To: T10 Technical Committee
From: Rob Elliott, HP (elliott@hp.com)
Date: 17 July 2007
Subject: 07-300r1 SAS-2 Configurable expander table-to-table error handling

Suggested changes

Figure 48 — Externally configurable expander device and table-to-table attachment [\[changed\]](#)

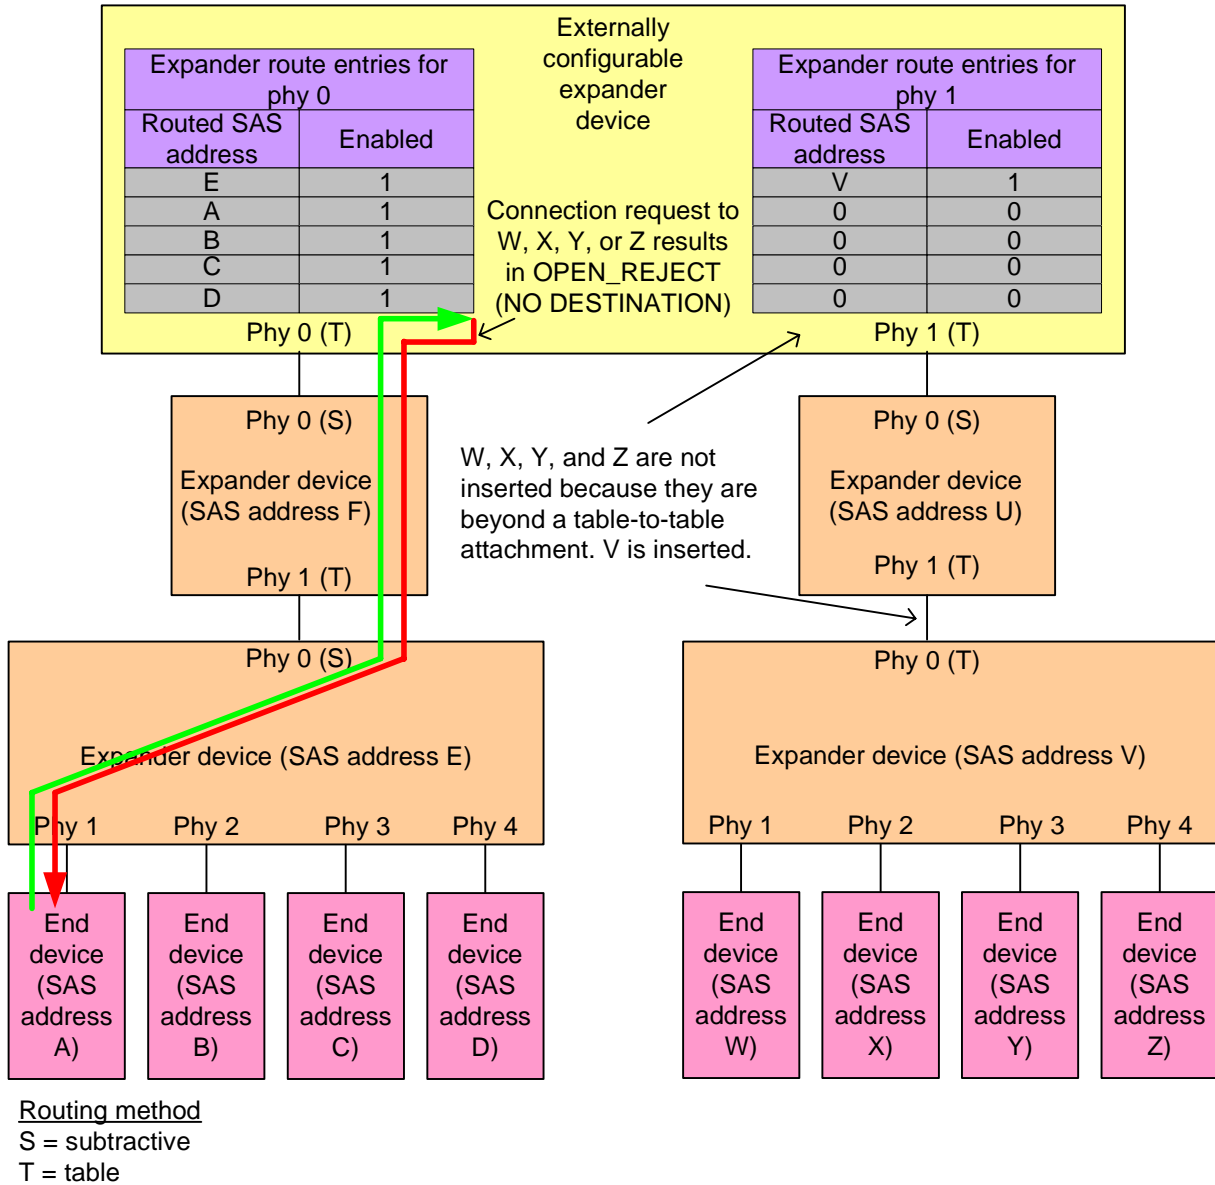
SAS addresses of devices attached beyond expander phys that are attached table-to-table shall not be included in the expander route table. The SAS address of the first expander device that is attached table-to-table shall be included and the SAS address of every device attached beyond that expander device shall not be included.

Figure 48 shows an example of a route table that does not include SAS addresses beyond a table-to-table attachment.
